Thames Tideway

Review of Tideway spills and their environmental impact.

Professor Chris Binnie

10th December 2014

Figure 1 Watersports Activity on the Thames Tideway

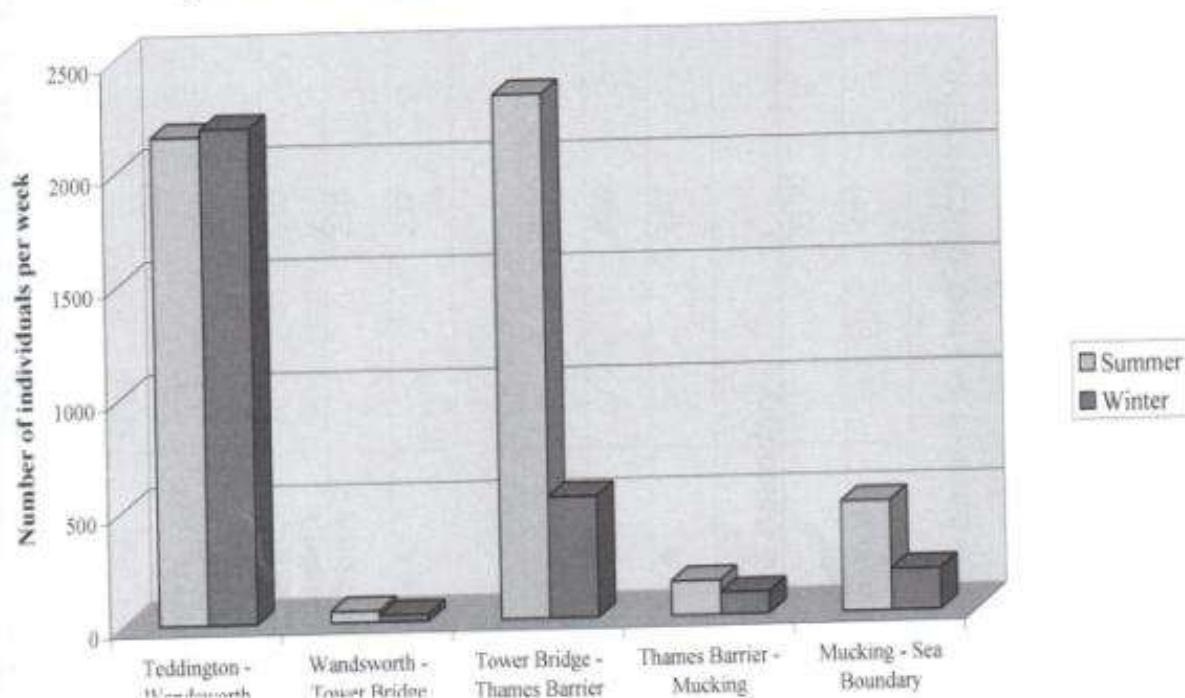
The foreshore is not frequently used as it is underwater for much of the day due to the tidal range of about 5m and there is limited access to it. It is generally muddy and uninviting. There is limited encouragement to use it. This is illustrated by the low numbers of users in the Wandsworth to Tower Bridge section of the Tideway. Thus its use is not significant.

Figure 1 - River Thames recorded salmon catch and five year rolling average

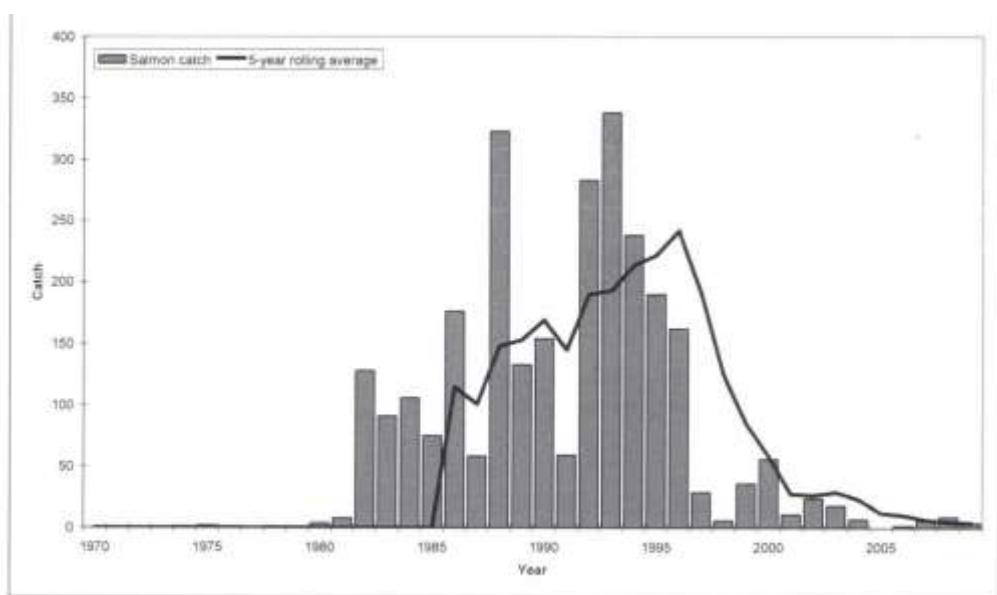
I have no recollection that the information about the drop in salmon numbers was passed to the TTSSG for it to consider whether salmon, were still sufficiently numerous to be considered as representative. The record of returning salmon in 2013, when the Mogden STW effluent had been much improved and was classified as satisfactory by the EA, was 3 salmon. From this one could conclude that, since the dissolved oxygen conditions in the Tideway in 2013 would have been better than in the 1980s, that returning salmon were not significantly impacted by the then dissolved oxygen conditions in the Tideway. Thus current Tideway conditions would be less likely to affect salmon migration through the Tideway.

Dr Friedland concluded "*Ocean thermal conditions in key post-smolt nursery areas are expected to continue to change, making marine survival unsustainable for segments of the stock complexes from both north America and Europe.*" My emboldening. He confirmed in a subsequent email that the unsustainable area included southern England.

The notes of the meeting of 31st May 2012 states "**...there is currently no evidence to challenge the hypothesis that salmon may not be sustainable in the longer term due to climate change.**" My emboldening.

Thus there seems no reason to consider the most sensitive fish species, salmon, in the representative fish suite. Discussion at the meeting on 31st May 2012 included consideration of other sensitive species that could replace salmon. These included sea trout. Generally about 15 are recorded as migrating each year and may be breeding but the evidence for this is limited, a small number. Shad are a rare migrant. One sturgeon has been found in the outer estuary but in the wild in Western Europe these are rare. No evidence was provided that any of these species would be present in sufficient numbers to be included within the representative suite of fish. as replacements for salmon.

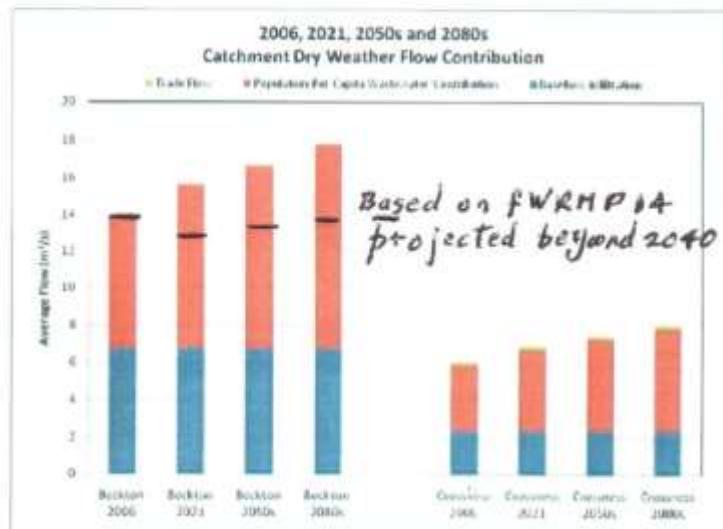
This is confirmed by the TTT 2006 Vol 2 page 10 which states “ *Of the 57 CSO which discharge to the Tideway, indicative flow data only exists for around 9 of the pumped discharges and there is some historical data. There is no flow data and virtually no quality data for the remainder. Obviously, comprehensive flow and quality data is essential for all these discharges if individual rainfall events are to be modelled precisely. “ Which they were. “It is likely that, depending on rainfall patterns, the quality of discharges from these outfalls will vary considerably throughout the event and each CSO will display a different pattern of discharge. It is also likely that antecedent conditions will influence the amount of solid material flushed from the system. Under these conditions it is unlikely that it will ever be possible to acquire sufficiently comprehensive data.”* ”

Later some data was recorded for a period at the West Putney CSO. The original modelled spill frequency of the West Putney CSO is shown in Appendix E to the TW Needs report of 2010 as a spill frequency of 59 spills/ year. The annual average spill volume, quoted as having come from TW, was 36,700m3. A monitoring device was installed in a chamber before the CSO discharge at West Putney. The number of spills was found to be 28 for the year. The record of the CSO spill volume for the year Sept 2010 to Sept 2011 was 20,100m3. So how wet was the period? The Heathrow average annual rainfall is quoted as 604mm/year which compares with 527mm during this period, so the monitoring period was somewhat drier than normal. The revised TW Table of performance quotes the spill frequency as 28. This reduction in spill frequency from 59 to 28 demonstrates the accuracy of the initially modelled spill frequency.

I have been unable to locate any other measurements of spill frequency or spill volume from any of the other gravity CSO. This may be because such measurements are difficult to obtain. However that does indicate how much reliance should be placed on such information.

Figure 3.1. Seasonal pattern of trap catches at Molesey, totals for date. a) 1986-1996, b) 1986-1993, and c) 1994-2008.

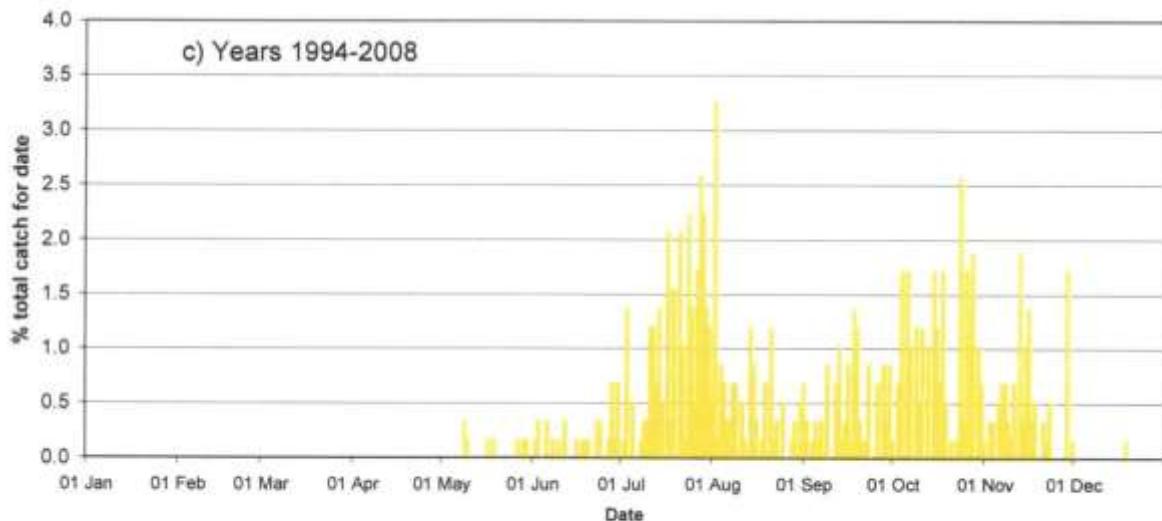
The salmon risk factor shown in the model above is about 0.5. This would mean that the salmon are in the Tideway almost all of the time. Salmon are a migratory species which would take probably about one week to pass through the main part of the Tideway. At other times they would be either at sea or higher up the river. The plot below, from Dr Solomon’s report River flow and salmon migration in the River Thames at Molesey 2011, shows the

timing of the arrival of salmon at the Molesey weir 1994 to 2008. This shows that salmon arrived there between June and the end of November.

Thus the salmon risk factor used in the model appreciably over-estimates the risk and hence the impact. Further as seen already, salmon are very limited in the Tideway, 2013 only 3 being recorded, the EA stating that they are not sustainable in the short to medium term and the models showing that due to changes in the Atlantic they will not be sustainable in the longer term.
